December 10, 1981

The Commission has issued the enclosed Amendment Nos. 80 , 76 and 49 to Facility License Nos. DPR-33, DPR-52 and DPR-68, respectively, for the Browns Ferry Nuclear Plant, Unit Nos. 1, 2 and 3. These amendments consist of changes to the Appendix B Environmental Technical Specifications in response to your request dated July 29, 1981 (TVA BFNP TS 165).

These amendments revise the Environmental Technical Specifications to:

ATTACHMENT TO LICENSE AMENDMENT NO. 80

THE OFFICE OF POWER
 ORGANIZATION FOR OPERATION
 OF NUCLEAR PLANTS
 Figure 5.2-1

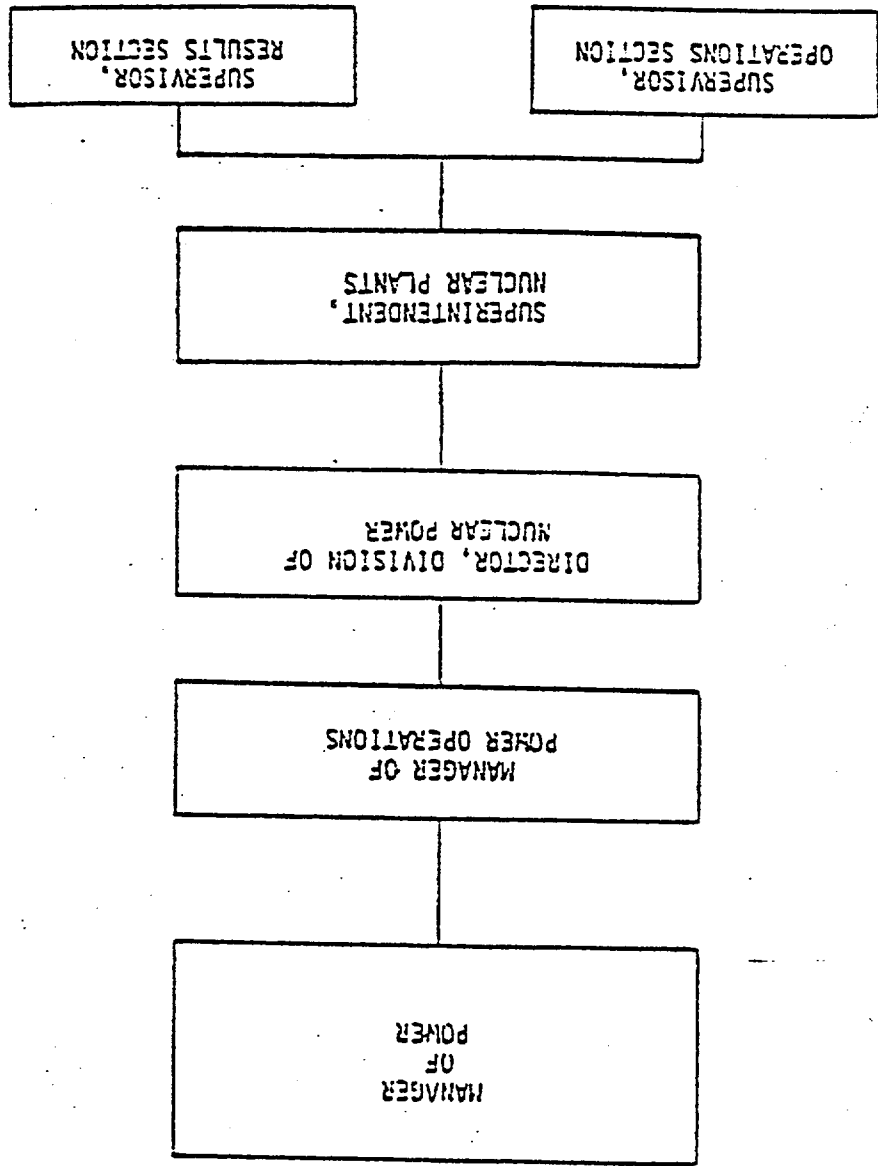
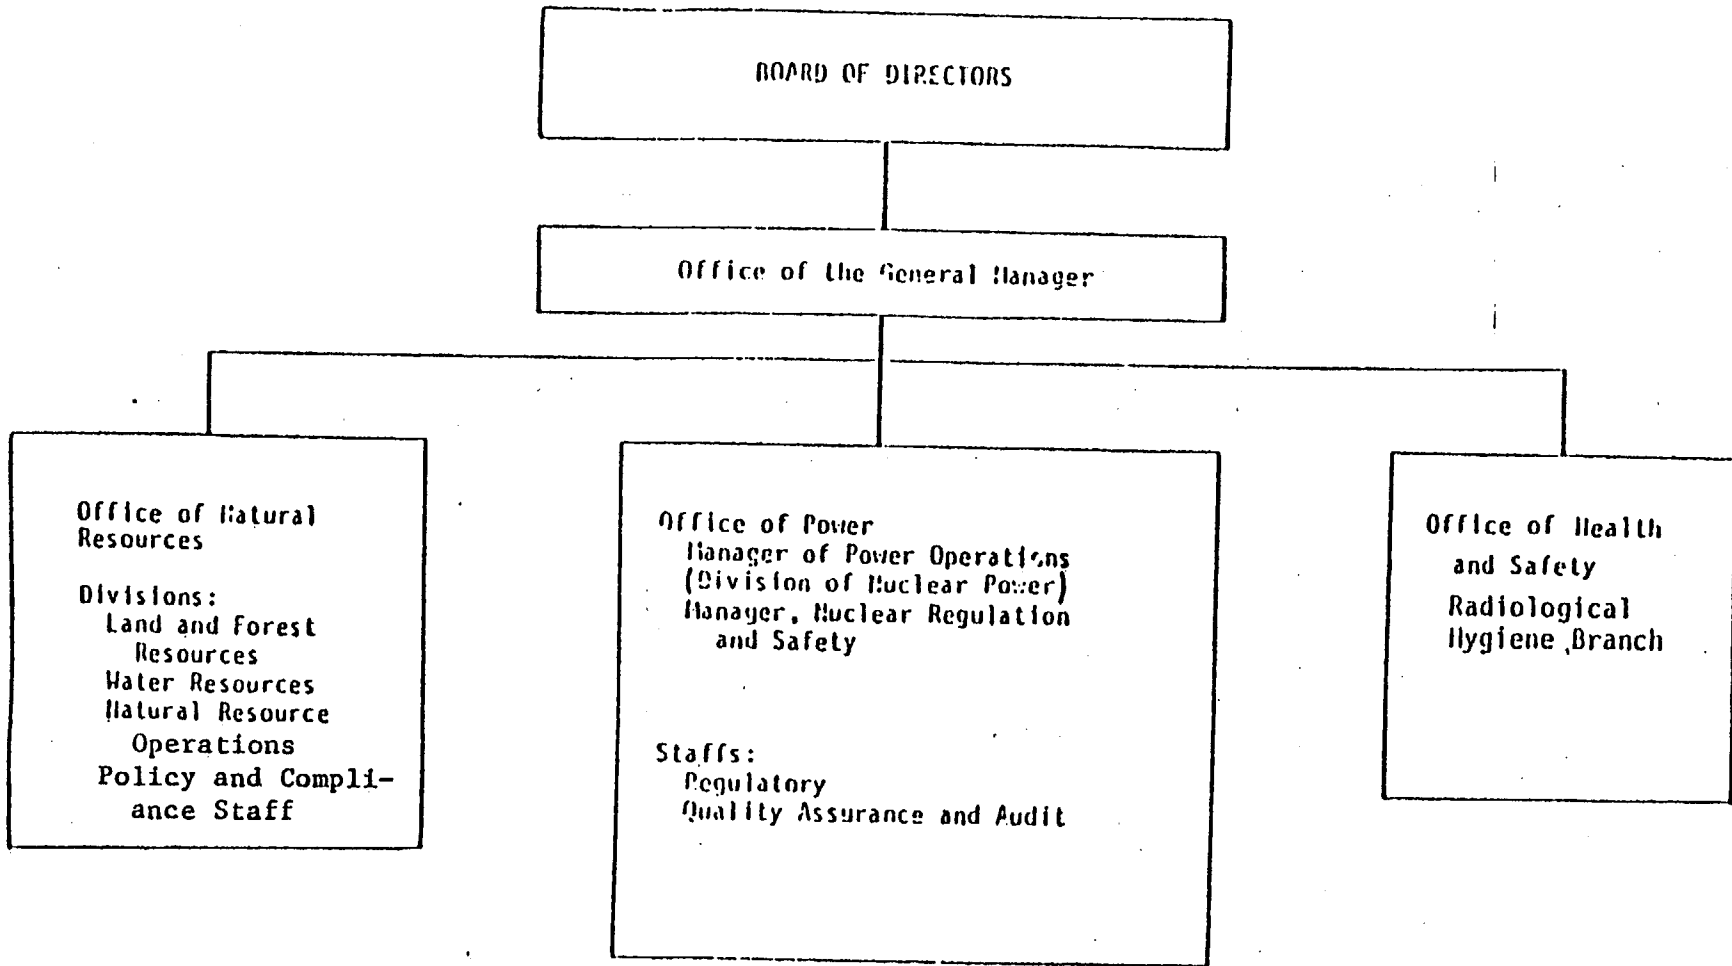
1. Delete the requirements in Section 4.1 for water quality surveys, thermal plume mapping, benthic monitoring, phytoplankton monitoring, zooplankton monitoring, fish population studies, entrainment studies on fish eggs and larvae and reference to a special study on chlorination which was completed several years ago.
2. Change the titles in Section 5.0 (Administrative Controls) of the offices within TVA responsible for environmental activities.

- 5.2.1 The organization of TVA management which directly relates to operation of the plant is shown on Figure 5.2-1.
- 5.2.2 The principal organizations within TVA which are concerned with environmental matters related to nuclear power plant operations are the Office of Power, Office of Natural Resources, and the Office of Health and Safety. The Office of Power is directly responsible for operating the plant in accordance with specified requirements and conducting onsite monitoring. The Office of Natural Resources and the Office of Health and Safety are responsible for providing technical guidance, assistance, monitoring, and other services as needed for environmental compliance. The organizations above report to the General Manager as shown in Figure 5.2.1.

Figure 5.2-1
 Organization for Operation
 of Nuclear Plants
 BROWNS FERRY NUCLEAR PLANT

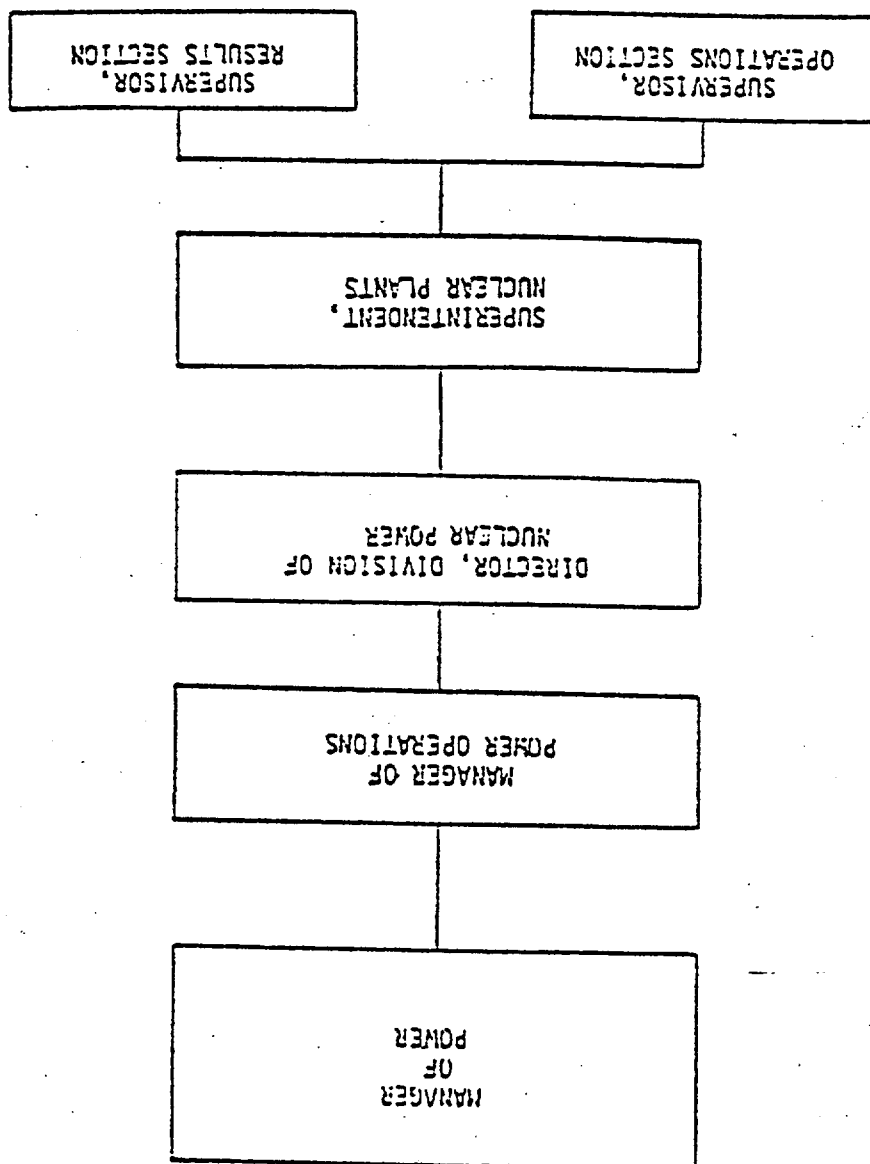
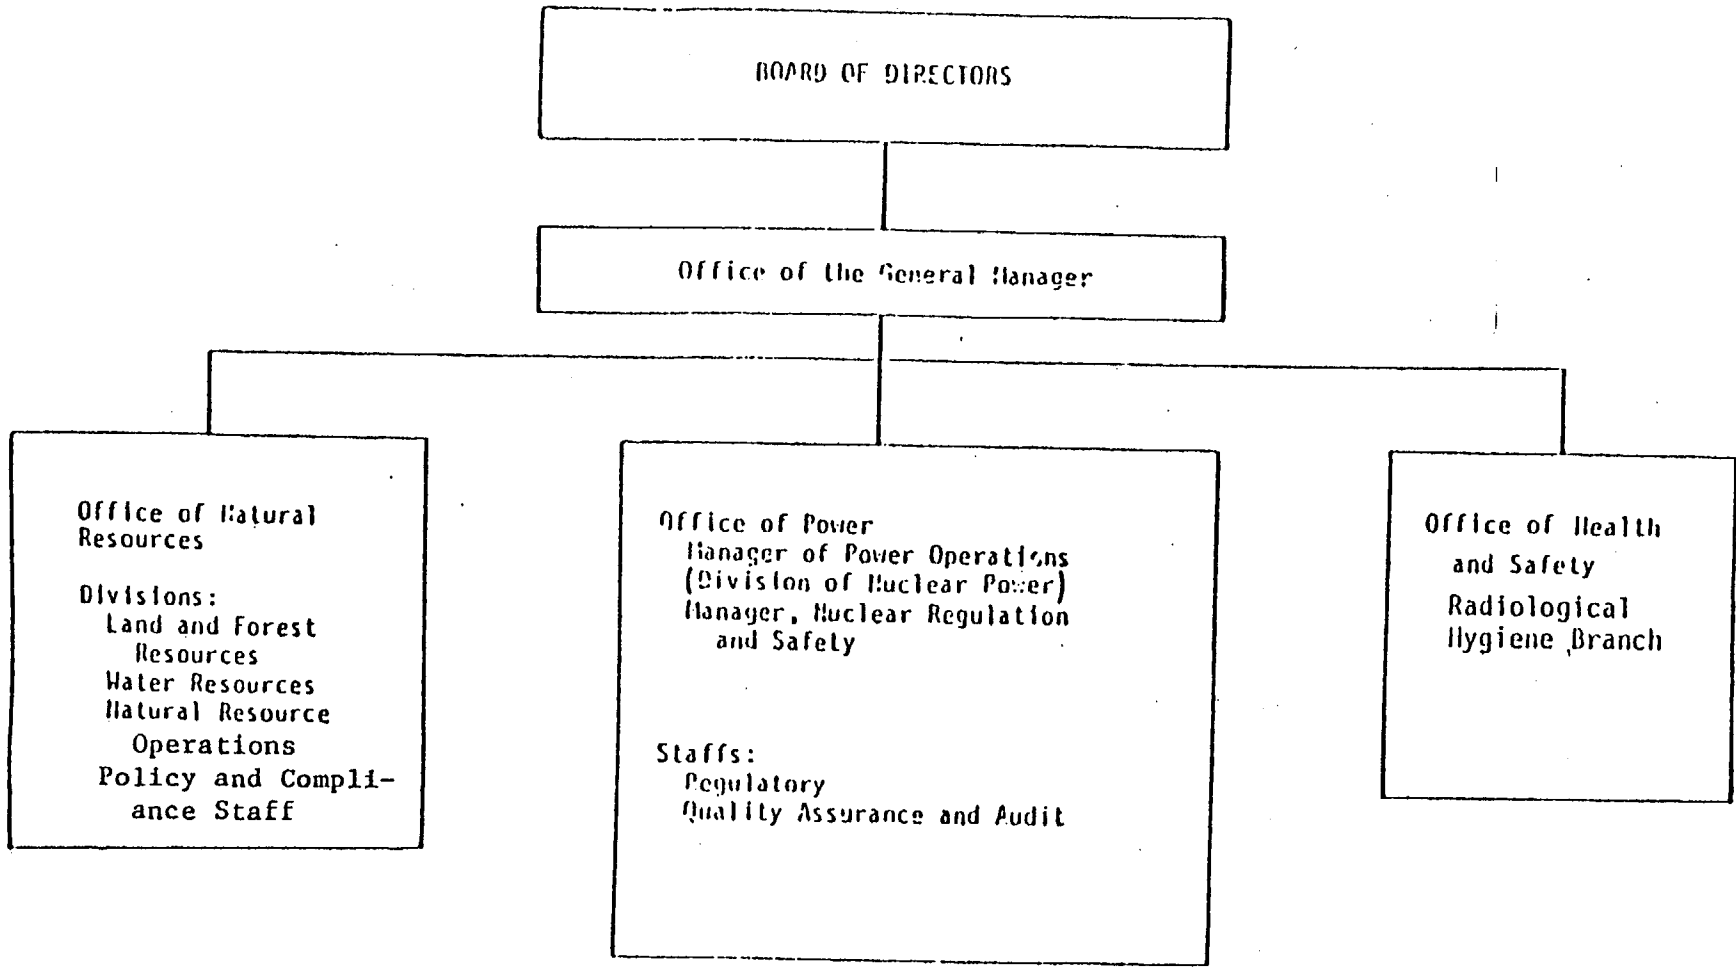
- 5.2.1 The organization of TVA management which directly relates to operation of the plant is shown on Figure 5.2-1.
- 5.2.2 The principal organizations within TVA which are concerned with environmental matters related to nuclear power plant operations are the Office of Power, Office of Natural Resources, and the Office of Health and Safety. The Office of Power is directly responsible for operating the plant in accordance with specified requirements and conducting onsite monitoring. The Office of Natural Resources and the Office of Health and Safety are responsible for providing technical guidance, assistance, monitoring, and other services as needed for environmental compliance. The organizations above report to the General Manager as shown in Figure 5.2.1.

Browns Ferry Nuclear Plant
 TVA Office of Power
 Organization for Operation
 of Nuclear Plants
 Figure 5.2-1

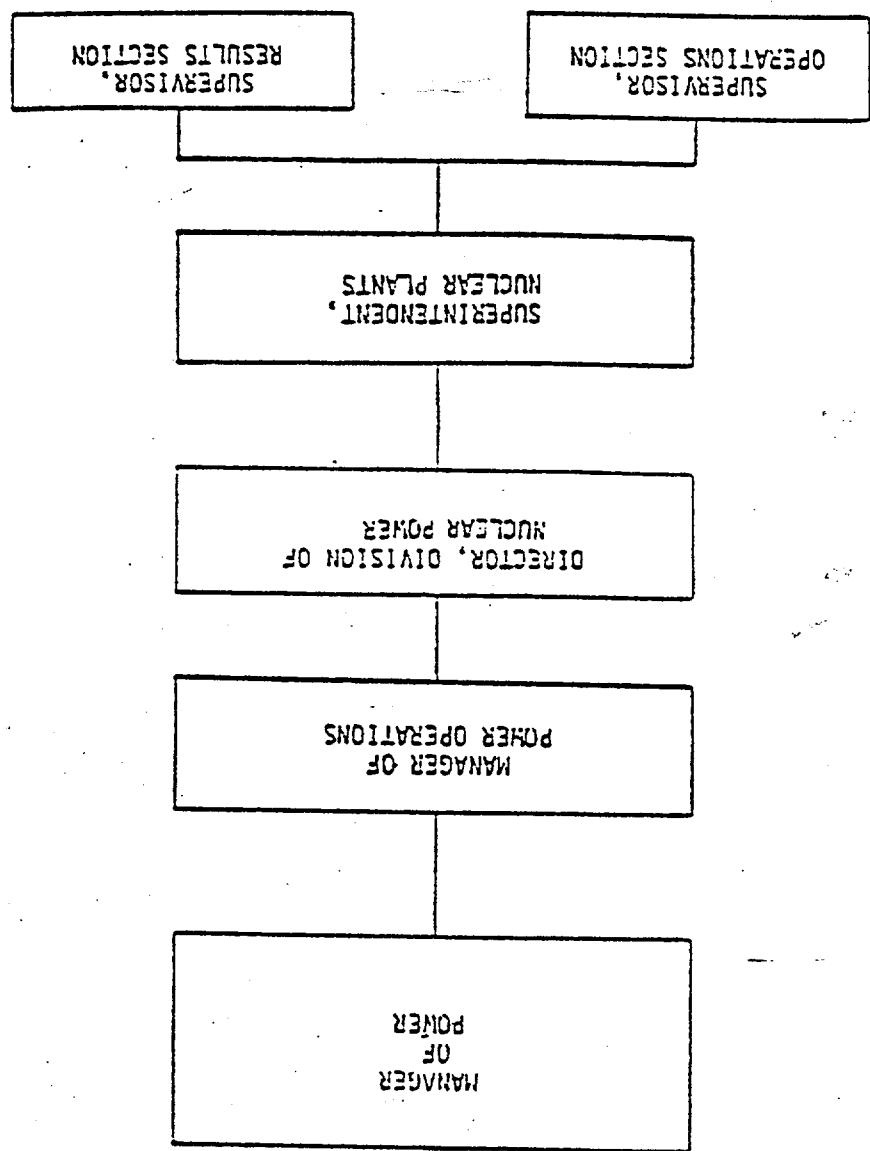
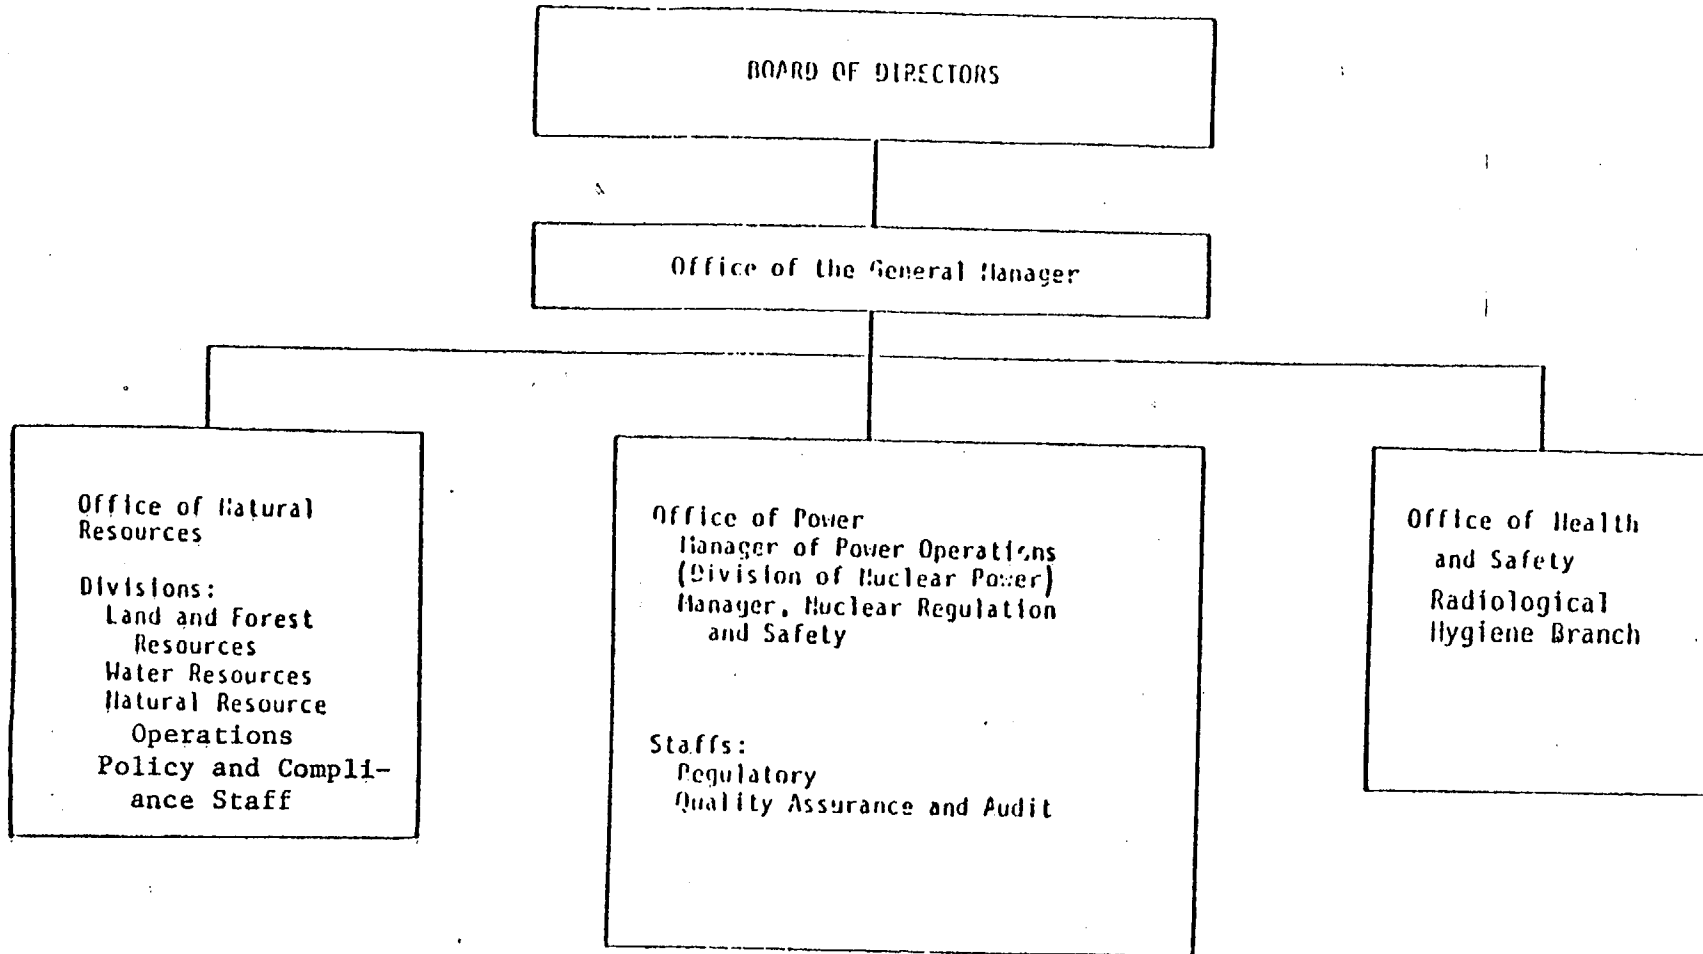
- 5.2.1 The organization of TVA management which directly relates to operation of the plant is shown on Figure 5.2-1.
- 5.2.2 The principal organizations within TVA which are concerned with environmental matters related to nuclear power plant operations are the Office of Power, Office of Natural Resources, and the Office of Health and Safety. The Office of Power is directly responsible for operating the plant in accordance with specified requirements and conducting onsite monitoring. The Office of Natural Resources and the Office of Health and Safety are responsible for providing technical guidance, assistance, monitoring, and other services as needed for environmental compliance. The organizations above report to the General Manager as shown in Figure 5.2.1.
